**IEEE P802.15**  
**Wireless Personal Area Networks**

Project	IEEE P802.15 Working Group for Wireless Personal Area Networks (WPANs)	
Title	<b>TG3 D10 running comment resolutions</b>	
Date Submitted	[8 July, 2002]	
Source	[James P. K. Gilb] [Apparent Technologies] [9921 Carmel Mountain Rd. #247, San Diego, CA 92129]	Voice: [858-538-3903] Fax: [858-538-3903] E-mail: [gilb@ieee.org]
Re:	[]	
Abstract	[This document is a record of comment resolutions for LB17.]	
Purpose	[To provide a record of the comment resolution for LB17.]	
Notice	This document has been prepared to assist the IEEE P802.15. It is offered as a basis for discussion and is not binding on the contributing individual(s) or organization(s). The material in this document is subject to change in form and content after further study. The contributor(s) reserve(s) the right to add, amend or withdraw material contained herein.	
Release	The contributor acknowledges and accepts that this contribution becomes the property of IEEE and may be made publicly available by P802.15.

## 1. Comment resolution, Vancouver to Schaumburg

**Figure 1—MSC for the creating a child piconet.**

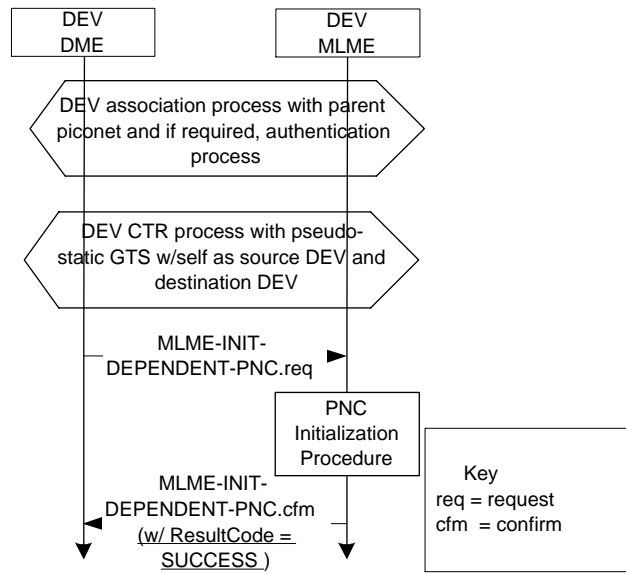
177 (Heberling, TR) - Figure 96 should be replaced with a proper MSC of the required protocol needed to establish a child piconet. Replace figure 96 with a proper MSC. **Suggest accept** ‘An MSC for child piconet initialization is included below. It needs twiddling to get the vertical lines to not show in the hex process blocks. Also, although consistent with other similar diagrams, this MSC seems to need the first beacon of the child PNC shown.

The MSC for creating a child piconet is illustrated in Figure 2.

**Figure 2—MSC for the initiating of a neighbor piconet.**

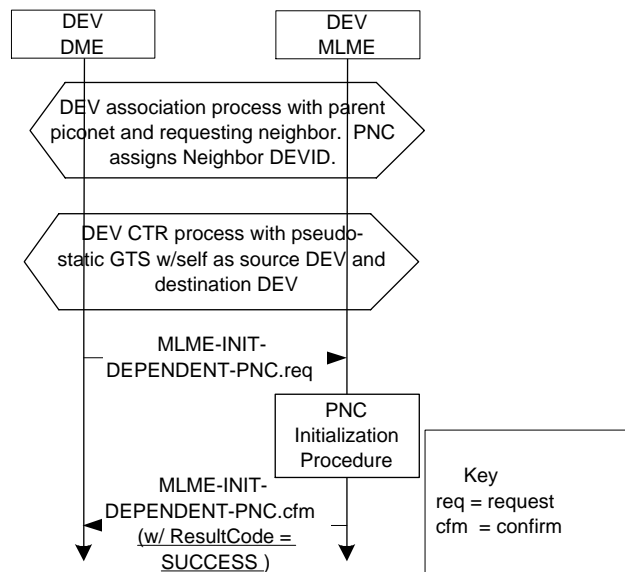
179 (Heberling, TR) - Figure 98 should be replaced with a proper MSC of the required protocol needed to establish a neighbor piconet. Replace figure 98 with a proper MSC. **Suggest accept** - An MSC for neighbor piconet initialization is included below. It needs twiddling to get the vertical lines to not show in the hex process blocks. Also, although consistent with other similar diagrams, this MSC seems to need the first beacon of the neighbor PNC shown.

The MSC for the initiation of the neighbor piconet is illustrated in Figure 4.

Figure 4—MSC for a approved asynchronous channel time request

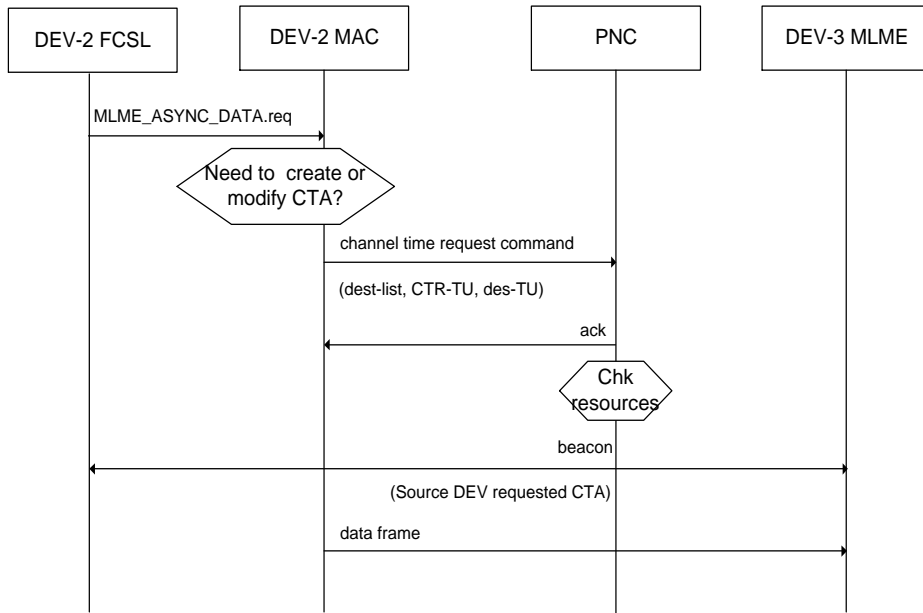
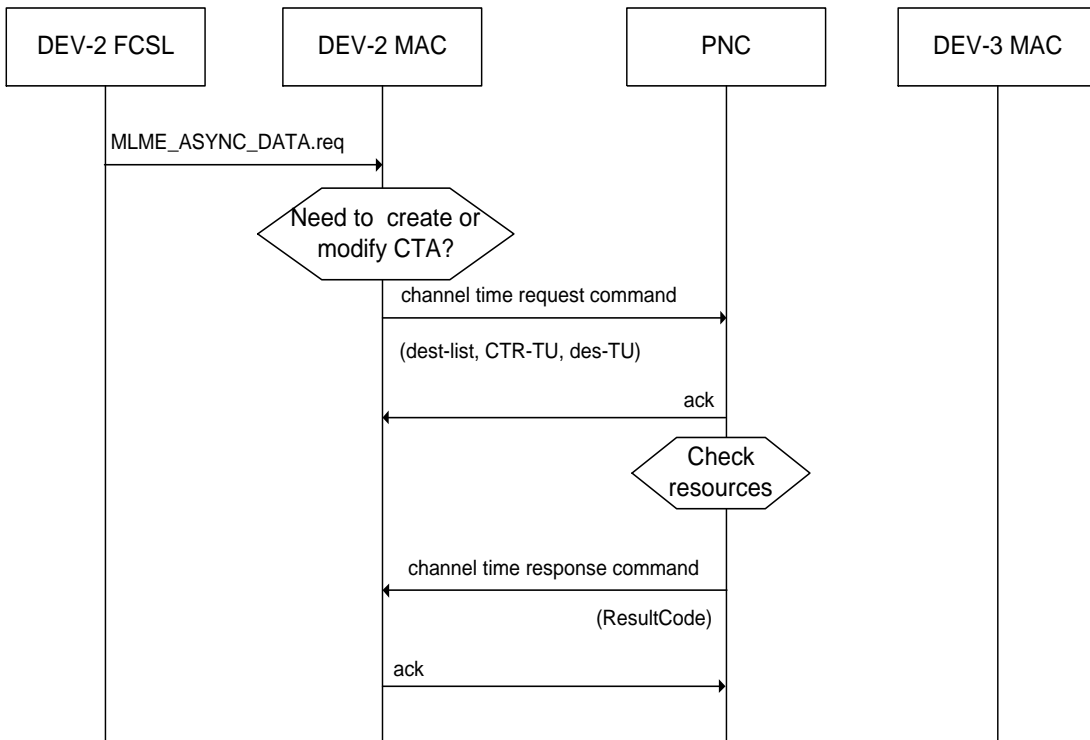
327 (Heberling, TR) Figure 119 is a flawed MSC of the Asynchronous channel time reservation process and data frame exchange. Consequently, delete the current MSC from this section of clause 8.5.2.1 and replace it with 02r0P802-15\_TG3-Asynch-channel-time-allocation.eps. **Suggest accept.**

Figure 119 – MSC for reserving asynchronous data channel time. Discussed earlier, new MSC is below:
